PG27.2.3

February 21, 2018
File 7795

**RE: Item No. PG.27.2
Draft Official Plan Amendment 393
ConsumersNext Secondary Plan**

Figure 2: Demonstration Plan from ConsumersNext Showing Proposed Built Form

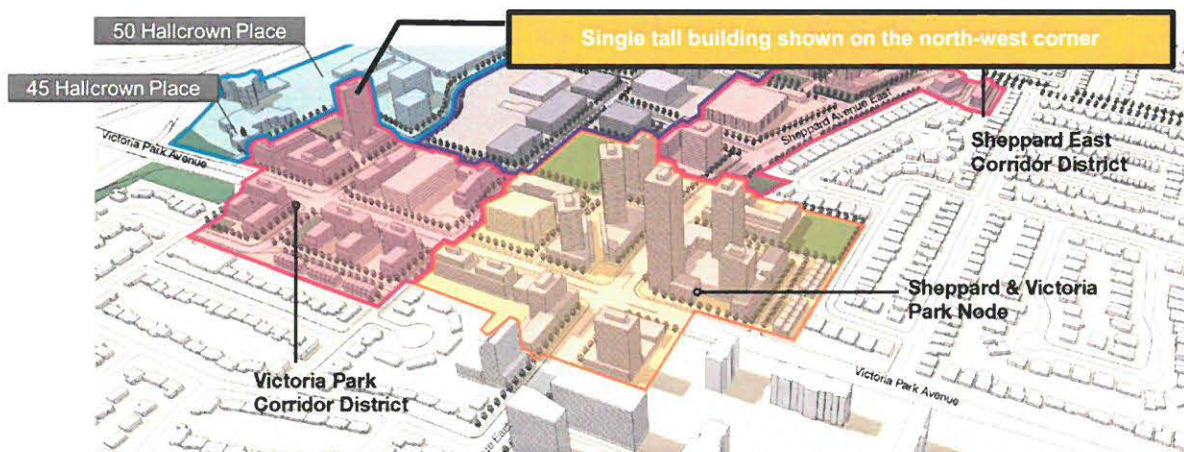
This policy is not consistent with the findings of the ConsumersNext Study. The Demonstration Plan contained within the ConsumersNext Final Report shows a singular tall building situated to the north-west corner of Consumers Road and Hallcrown Place. We request that Staff modify this policy to ensure that the vision brought forward through the ConsumersNext Planning Study is maintained.

As currently written, the policy suggests that multiple tall buildings may be permitted to be located anywhere within the District, whereas the Demonstration Plan only shows one tall building. As stated in our previous written comments, and as discussed with Staff in our meetings, height and massing should be directed away from the ACC lands as much as possible in order to limit overlook, limit negative impacts on sky views and to preserve the views to the church. Our previous endorsement of the Demonstration Plan was founded on the basis of Staff's commitment to concentrate height and massing away from the ACC lands in the form of a single, slender tower located at the north-west corner of Hallcrown Place and Consumers Road.

Proposed **policy 5.16.5(d)** should be revised to better reflect the Demonstration Plan as endorsed by the community and should include additional performance standards to better guide the design and placement of the tall building that is anticipated to be located to the north of the ACC lands, including maximum floorplate size and language regarding where a tower may be positioned. Additionally, specific building heights should not be prescribed in the Secondary Plan.
